To: Plan Holders for Improvements to the
Springfield-Branson National Airport
Springfield, Missouri
MoDOT Project No. AIR 126-092A1
West Kearney Terminal Parking Lot and GA Redevelopment

Transmitted herewith is **Addendum No. 1** to the Contract Documents, Plans and Specifications dated December 9, 2013 for Improvements to the Springfield-Branson National Airport, Springfield, Missouri, MoDOT Project No. AIR 126-092A1.

**ADDENDUM NO. 1
TO
CONTRACT DOCUMENTS, PLANS AND SPECIFICATIONS
FOR IMPROVEMENTS TO THE
SPRINGFIELD-BRANSON NATIONAL AIRPORT
SPRINGFIELD, MISSOURI
MoDOT PROJECT NO. AIR 126-092A1**

JOINT TRENCH DETAIL

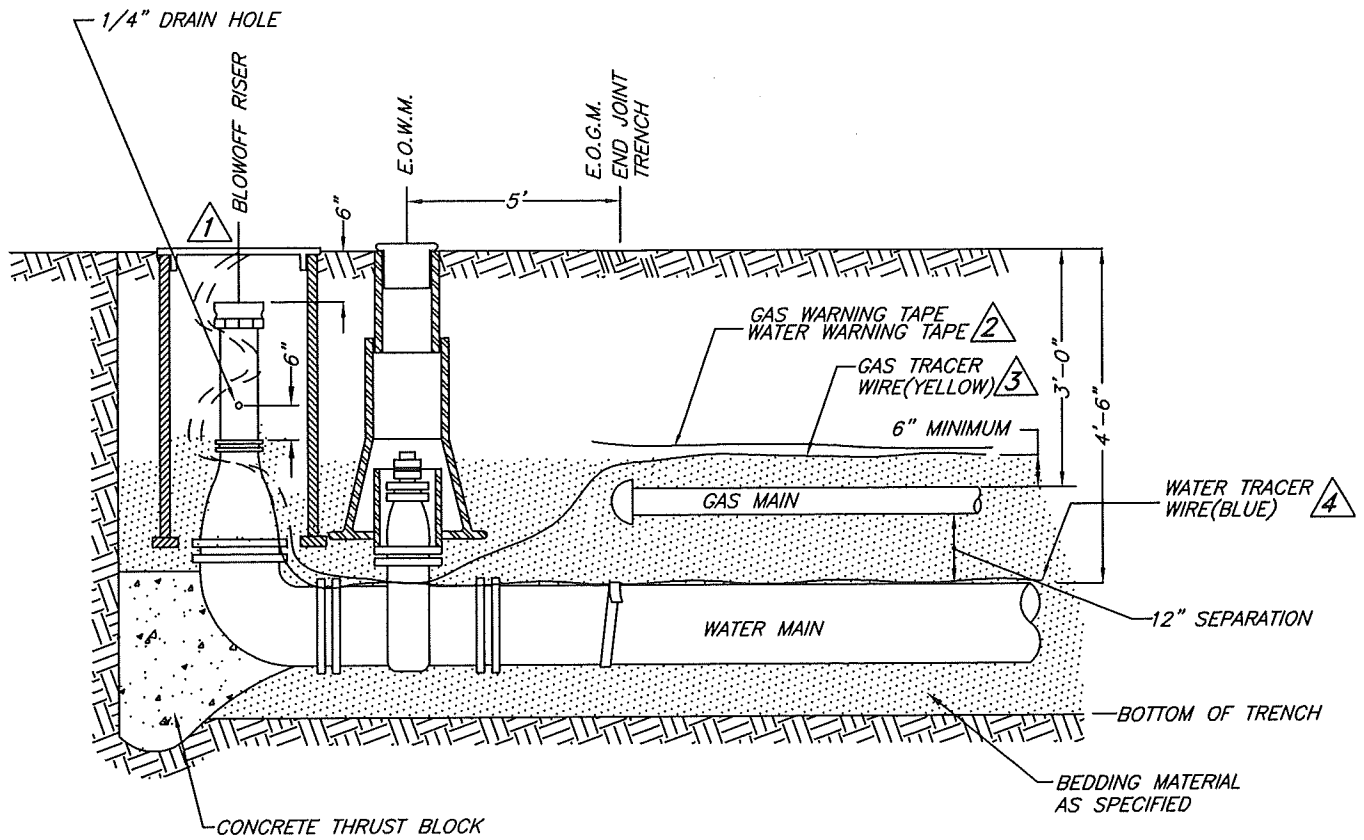
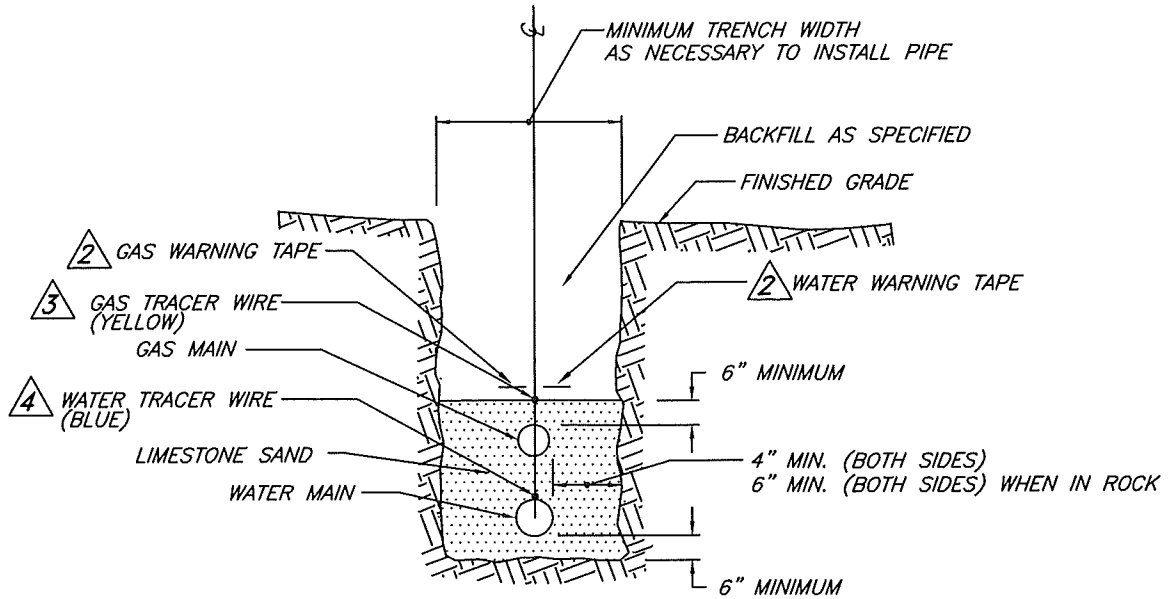
- a) Please find attached the Joint Trench Detail per the City Utilities Construction Standard of Springfield, Missouri.
